SCOPE OF WORK

SOHO BEACH HOUSE - MANDOLIN BEACH
4385 Collins Avenue | Miami Beach, Florida 33141

City of Miami Beach HPB - Final Submittal

Revised October 24, 2016

MANDOLIN VARIANCE KEY PLAN
SCALE: N.T.S.

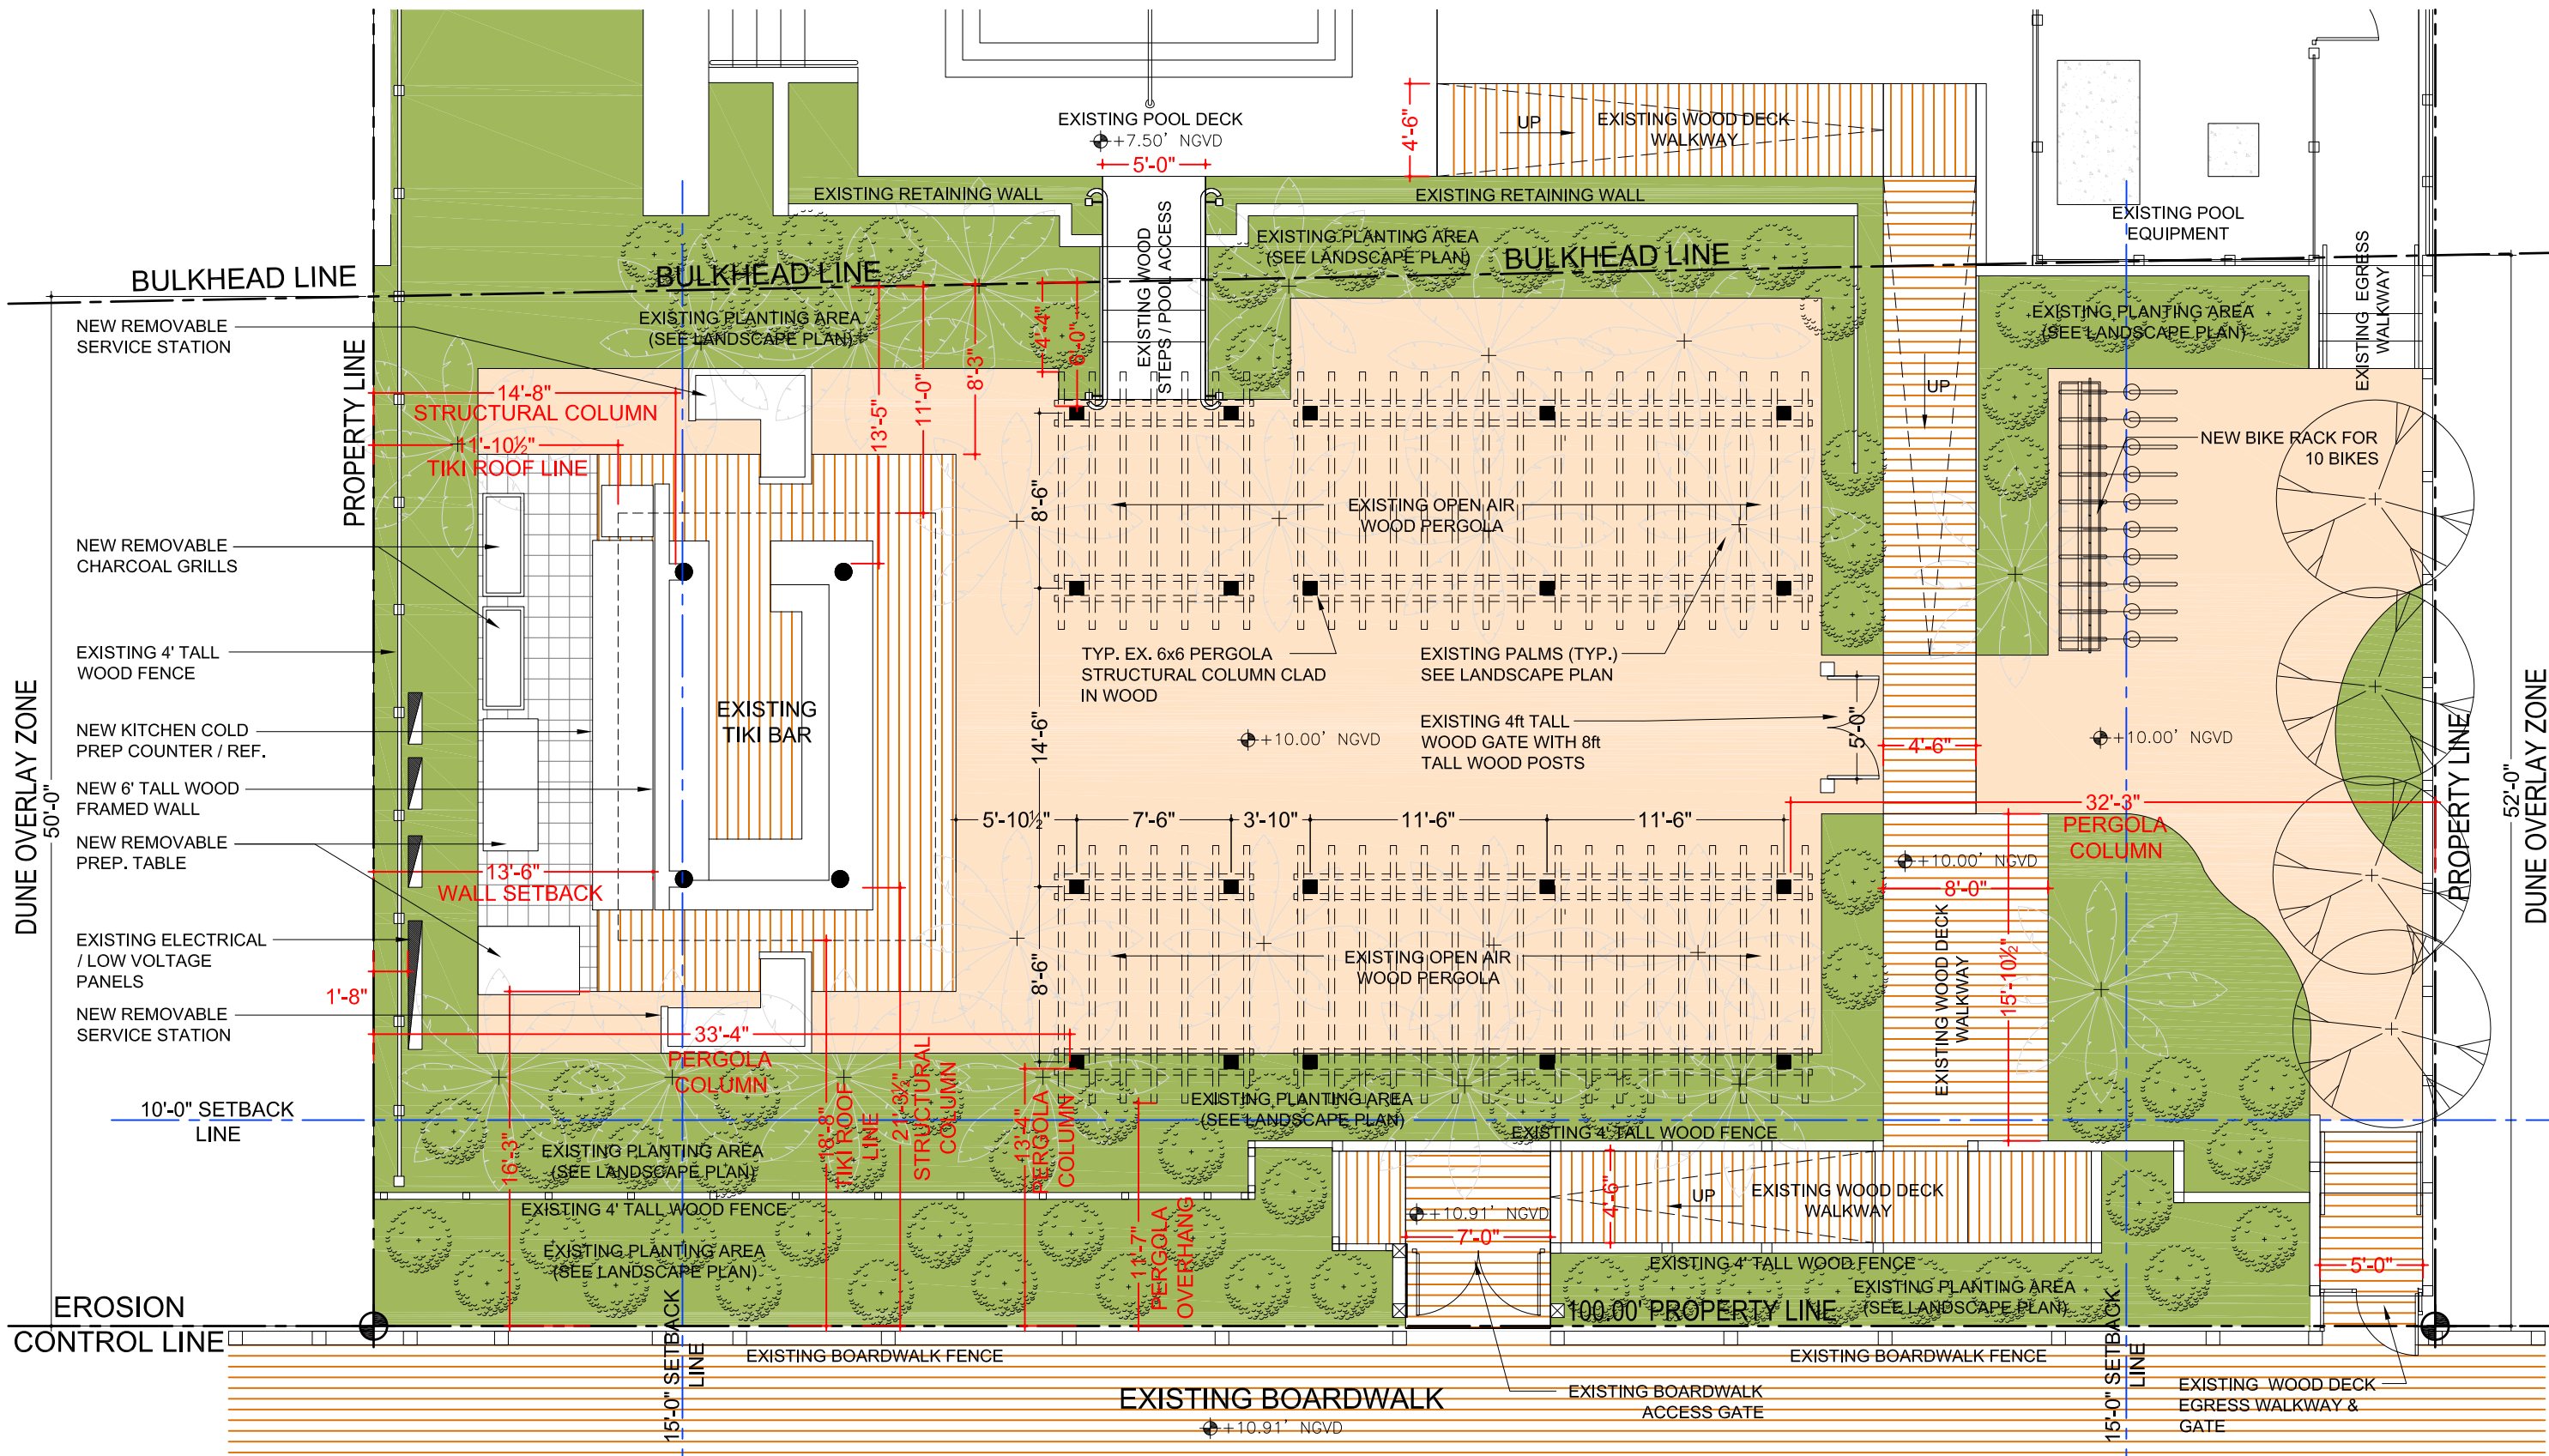
- REVISÉD / REDUCED
- ① After-the-fact variance of Section 142-774(1) to exceed by 2'-0" the maximum allowed clear space of 8'-0" between the roof covering and finish floor in order to retain the existing previously approved tiki hut bar structure with clear space of 10'-0" measured from finish floor to the roof and located within the Dune Preservation Overlay district.

- ④ After-the-fact variance of Section 142-775(d) to reduce by 4'-2" the minimum required side setback of 15'-0" within the Dune Preservation Overlay District in order to retain the existing previously approved tiki hut wood deck at 10'-10" from the south side property line.

- ⑦ After-the-fact variance of Section 142-774(2) to retain two pergola structures constructed of metal clad in wood where only wood materials are allowed for structures located within the Dune Preservation Overlay District.

- ⑨ After-the-fact variance of Section 142-775(a) to reduce by 12.96% (657 square feet) the minimum required open space of 80% (4,056) in order to retain a tiki hut bar, walkways, two pergola structures and provide an open space of 67% (3,399 square feet) within the Dune Preservation Overlay District.

- ⑩ After-the-fact variance of Section 142-775(b) to reduce by 4'-11" the minimum distance separation of 10'-0" between structures located within the Dune Preservation Overlay District in order to retain a tiki hut bar structure, pergolas and retractable roof structures with a distance separation of 5'-1".

VARIANCES ② ③ ⑤ ⑥ ⑧ ⑪ HAVE BEEN ELIMINATED
